Subject: DRIVER SEAT GRADUALLY MOVES DOWN BY ITSELF - (MANUAL SEAT ONLY)	Bulletin No.: 09-029/19
	Last Issued: 07/26/2019

2016-2017 CX-3 vehicles (without power seats) with VINs lower than JM1DK*****166827 (produced before Feb. 2, 2017)

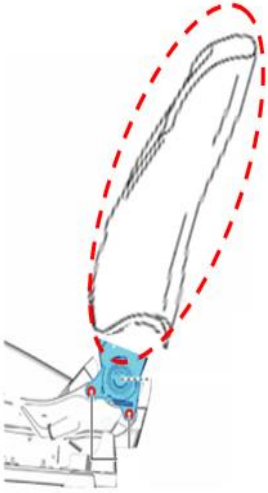
NOTE: Be sure that the customer's thigh is not touching the adjuster by mistake when getting in and out of the vehicle.
